<b>Company</b>	Trenz Electronic GmbH
<b>PCN Number</b>	PCN-20210119a
<b>Title</b>	TE0713-02 DDR3 and Flash Change
<b>Subject</b>	BOM change
<b>Issue Date</b>	(2021-01-19), Revised 2021-03-09

### 2.1 #1 Change DDR3 RAM (U15, U19) from IM4G16D3FABG-125I to IS43TR16256BL-125KBLI

## 2.3 #3 Set S/N to not fitted

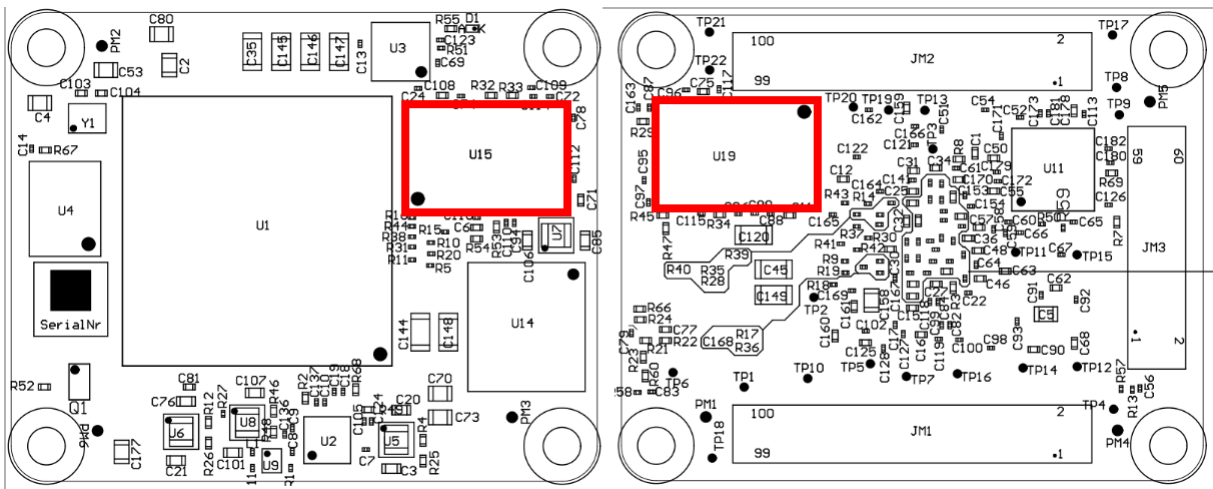
**Type:** BOM change

**Reason:** Part is end of life.

**Impact:** Track it pad no more available.
